North Campus Faculty Housing Phase II Project No. FM110407L/986315 Addendum No. 3

September 16, 2011

ADDENDUM NUMBER 3

J-BOX AT

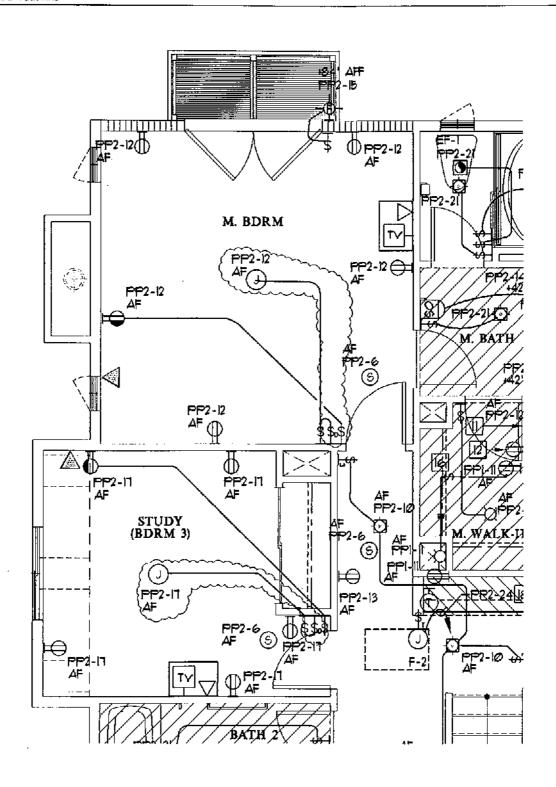
Bedroom J-box: Frovide j-box, listed for ceiling suspended fan support, located at center of bedroom with dual switch (dimmer switch for light and fan switch) at door for future fan light combo by tenant. See sketch general B for detail-Typical for all type of unit.

REMOVE EXTRA
OUTLET FOR
FUTURE RADON
FAN

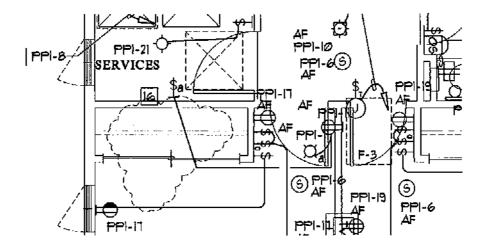
General comment: Outlet for future Radon fan

RELOCATE FUT. OUTLET FOR RADON FAN

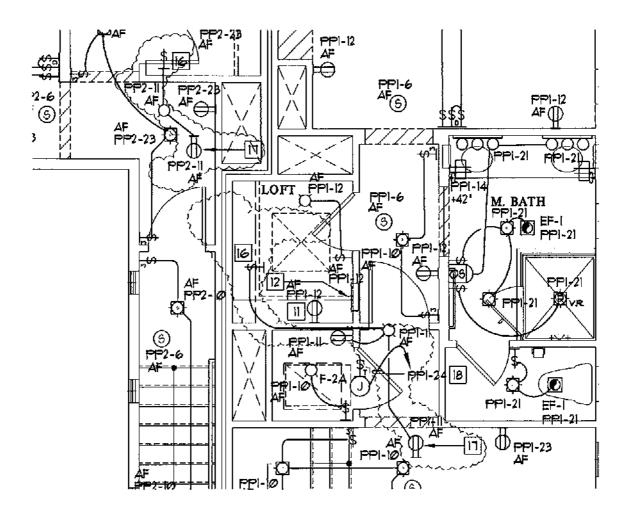
General comment: Outlet for future Radon fan

Item C-1: Location of the cable connection at study

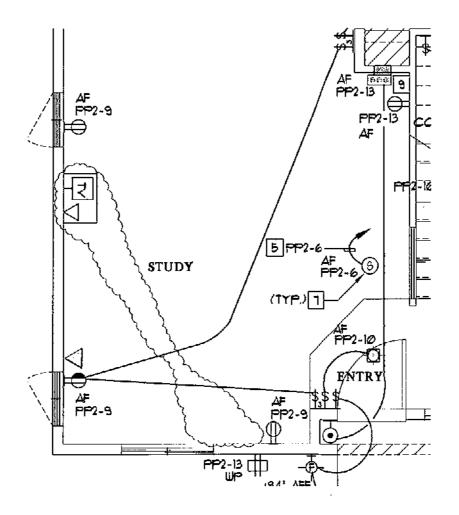
Cable connection for study located at unit 50R on building 400AR to be relocated to larger wall to allow more room for TV installation.

Cable connection for study located at unit 50 on building 4008 to be relocated to larger wall to allow more room for TV installation.

Cable connection for study located at unit 5.1R on building 600AR to be relocated to larger wall to allow more room for TV installation.

DINING ROOM J-BOX LOCATION

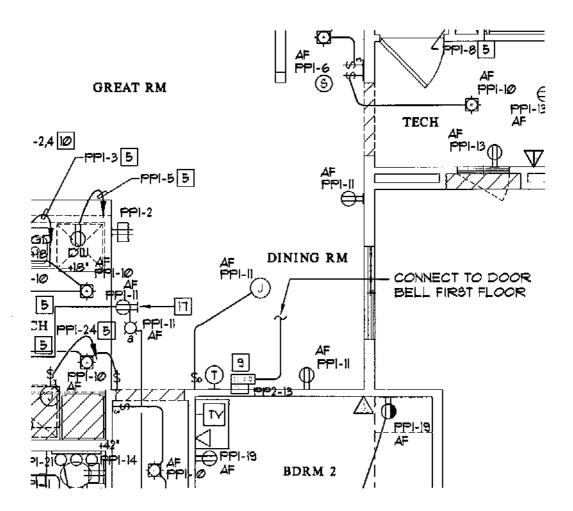
J-box at dining room should be on top and at center of dining table. Architect will show dining table for locating this J-box.

CABLE
CONNECTION
ADJACENT TO
FIRE PLACE

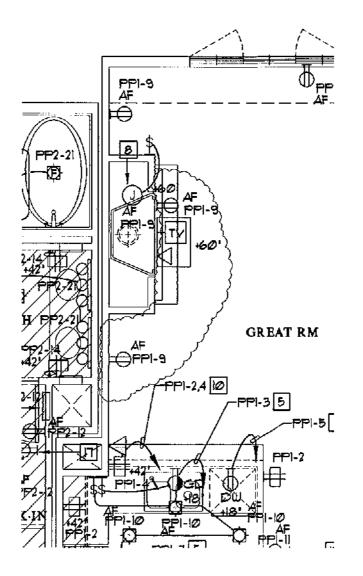
All cable connection adjacent to fire place to be relocated out of niches and be relocated to the wall above fire place at +60°AFF (field verify) for flat screen TV installation.

LAUNDRY ROOM LIGHT AND SWITCH ADDED

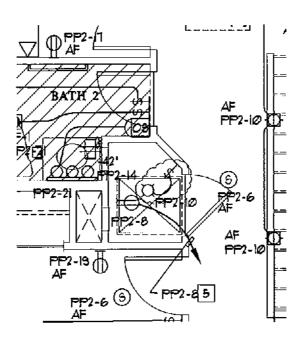
Item I-28: Light fixture at laundry room.

One surface round drum light with switch control to be installed in laundry closet at the following areas:

Unit 50R at building 400AR
Unit 50 at building 400B
Unit 5.1 at building 600A
Unit 5.1R at building 600AR
Unit 5.1 at building 600B

WALK-IN CLOSET LIGHT FIXTURE WATTAGE REVISED

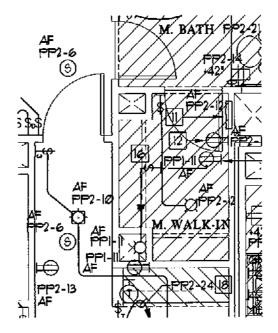
Item 1-30: Light fixture at walk-in closet.

Light fixture at walk-in closet to revise to two 26W compact fluorescent lamps to provide twice light level at closet. (Typical for whole project)

TITLE
BLDG. 300A
161 FLOOR
PLUMBING PLAN

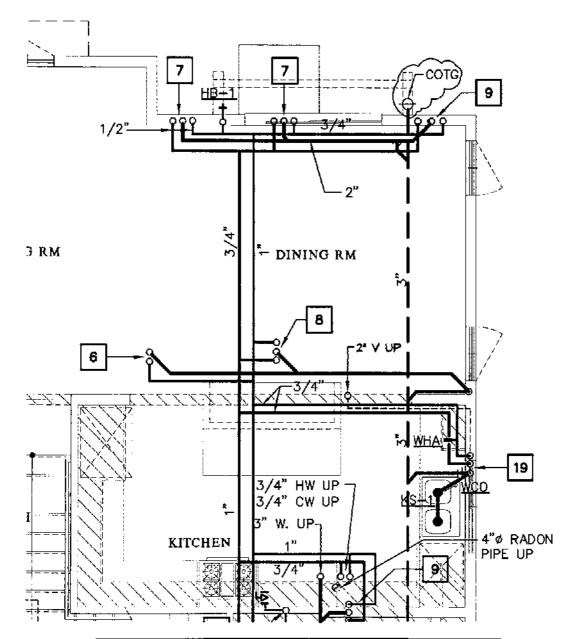
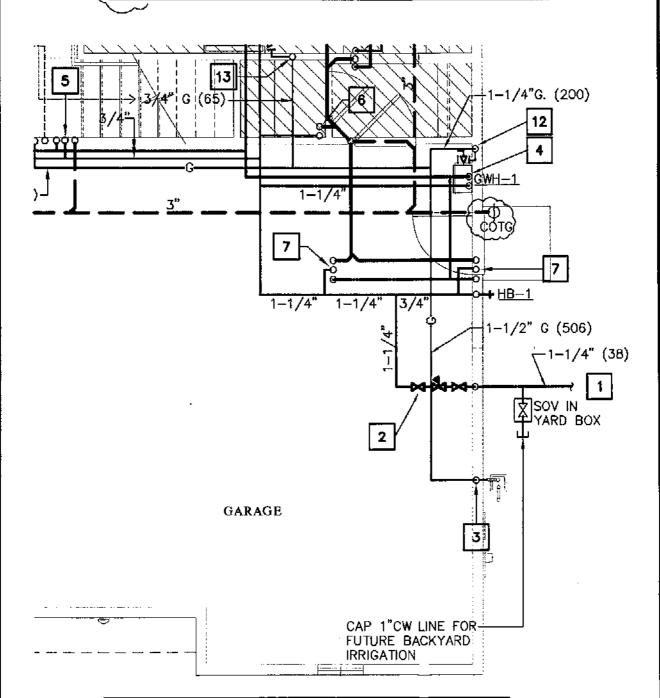
NOTE: CLEANOUTS SHALL BE CLOSE TO THE FLOOR AND 2"-4" FROM THE WALL TO KEEP CONSISTENCY.

TITLE BLDG. 3000AX 197 FLOOR PLUMBAG PLAN

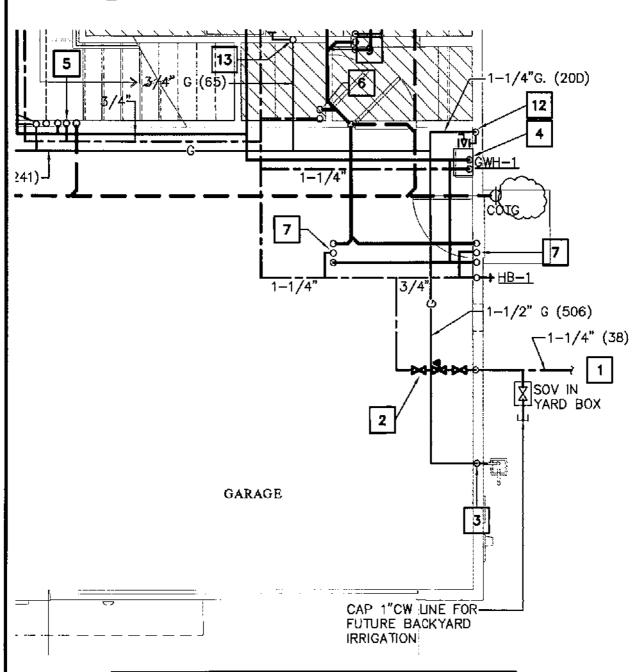
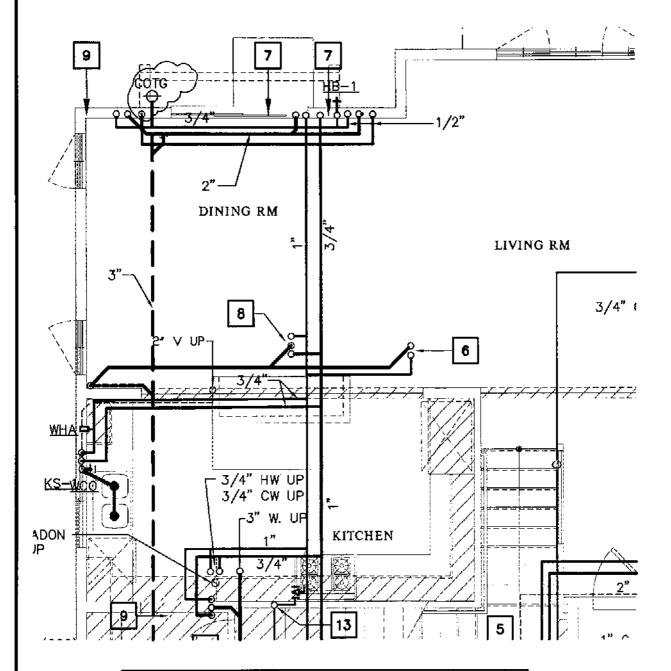
NOTE: CLEANOUTS SHALL BE CLOSE TO THE FLOOR AND 2"-4" FROM THE WALL TO KEEP CONSISTENCY.

TITLE BLDG 90008 BT RLOOK PLIMBING PLAN

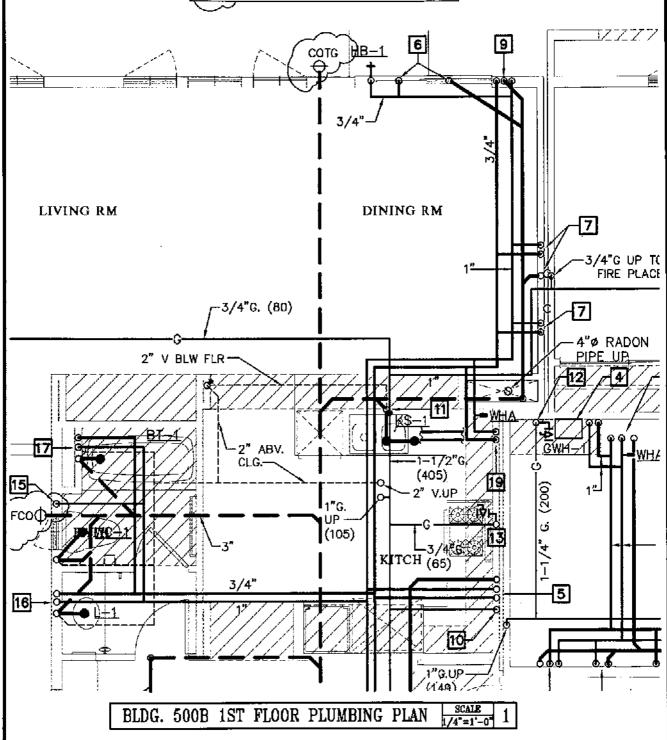
NOTE: CLEANOUTS SHALL BE CLOSE TO THE FLOOR AND 2"-4" FROM THE WALL TO KEEP CONSISTENCY.

BLDG 600A BT RLOOR PLUMBING PLAN

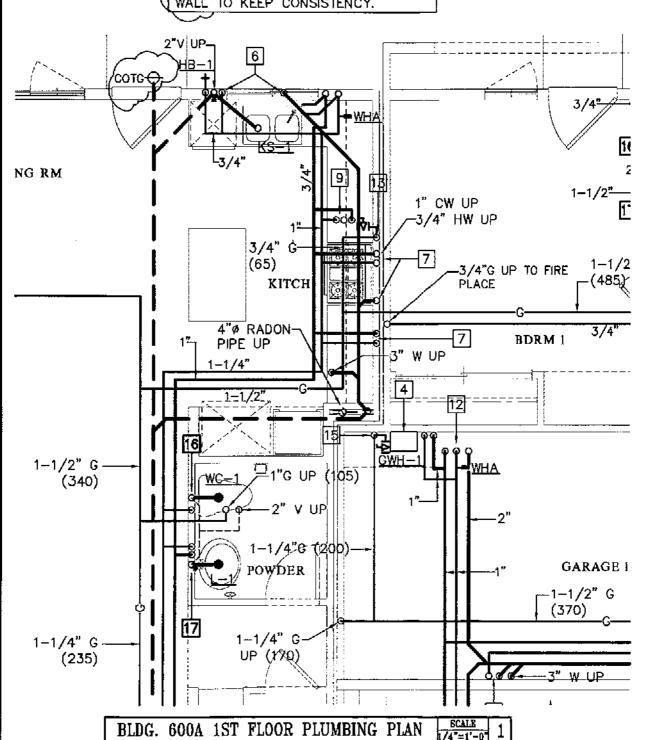
NOTE: CLEANOUTS SHALL BE CLOSE TO THE FLOOR AND 2"-4" FROM THE WALL TO KEEP CONSISTENCY.

TITLE
BLDG 600AR
161 FLOOR
PLIMBING FLAN

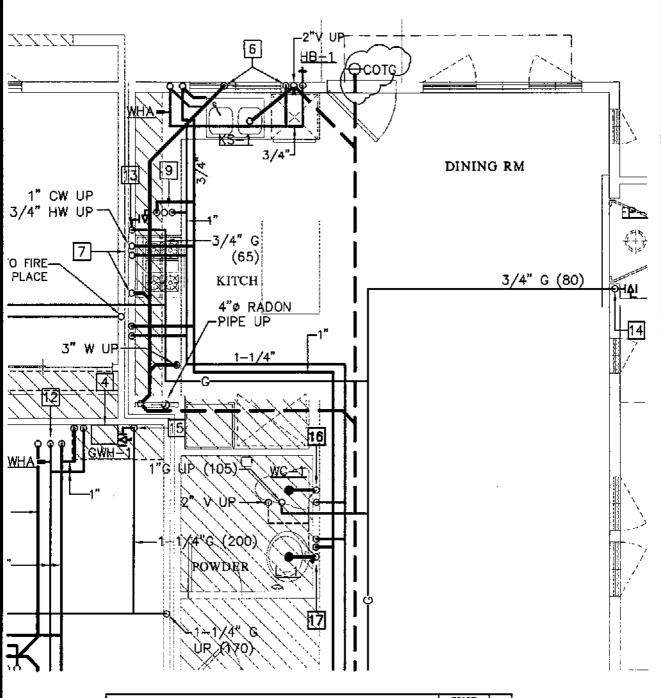
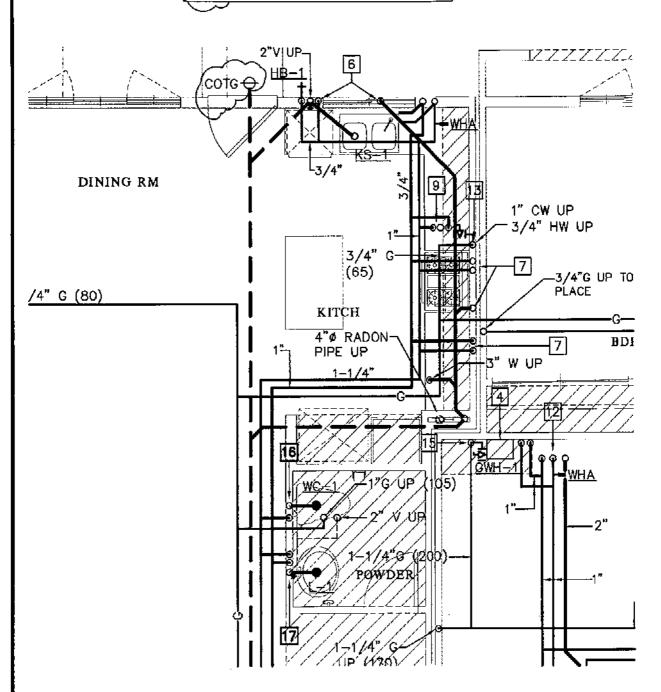
NOTE: CLEANOUTS SHALL BE CLOSE TO THE FLOOR AND 2"-4" FROM THE WALL TO KEEP CONSISTENCY.

ADDITIONAL DETAIL 23/AD5.1

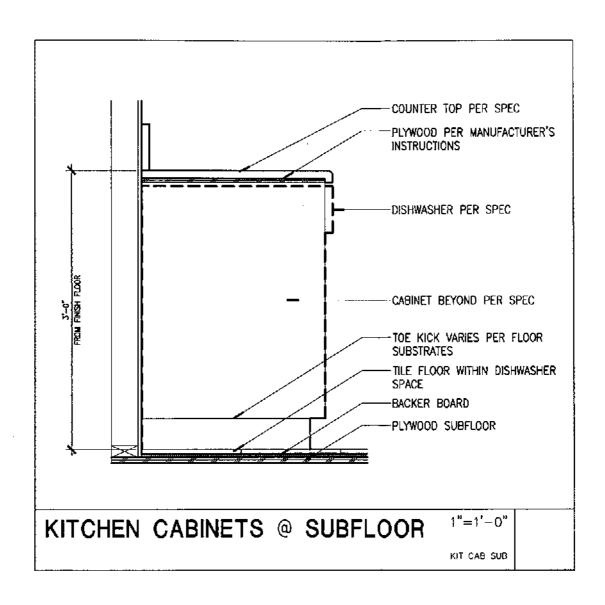
5. ADD Sketch 1 of 2 Addendum 3 Additional Detail 23/AD5.1 to Sheet AD5.1 Architectural Details.

MODIFICATION TO DETAIL 14/AD5.1

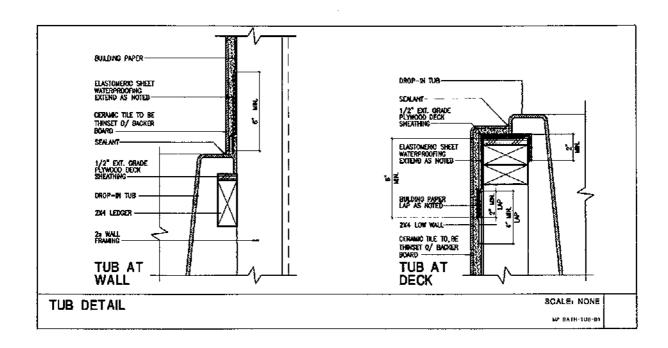
4. **DELETE** Detail 14 from Sheet No. AD5.1 Architectural Details and **REPLACE** with attached Sketch 2 of 2, dated 9/09/11.

ADDITIONAL DETAIL 15/AD1,2

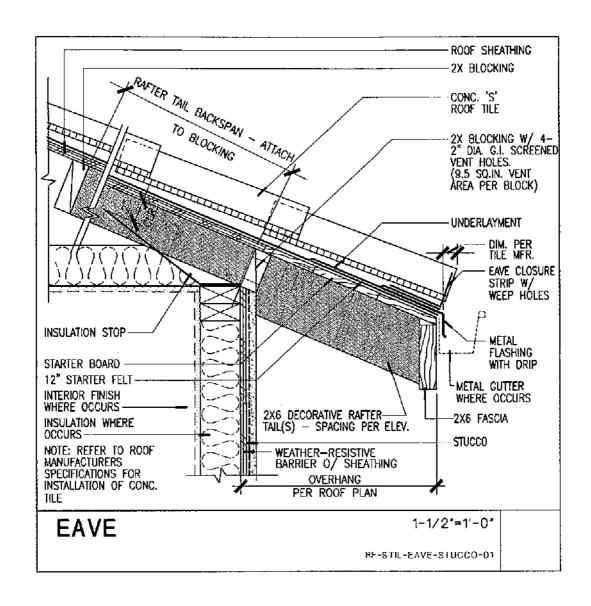
9. **ADD** Sketch 1 of 1 Addendum 3 additional detail 15/AD1.2 to Sheet AD1.2 Architectural Details.

REPLACE DETAIL 1/AD5.1

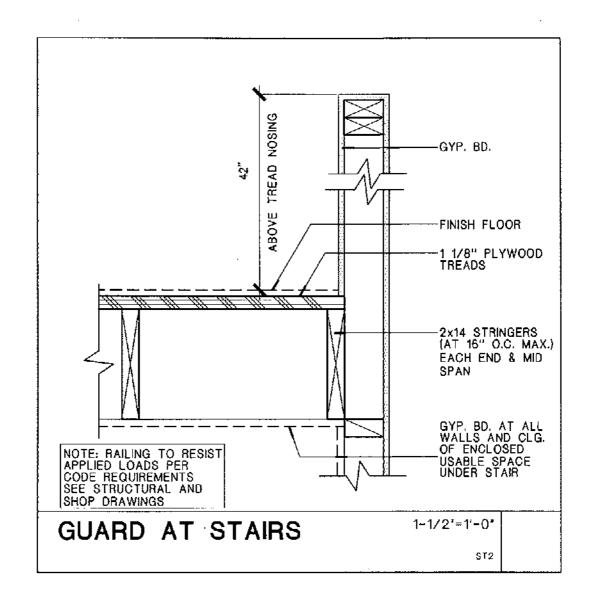
11. **DELETE** Detail 1 & 6 from Sheet No. AD5.1 Architectural Details and **REPLACE** with attached Sketches 2 of 3 and 3 of 3, dated 9/13/11.
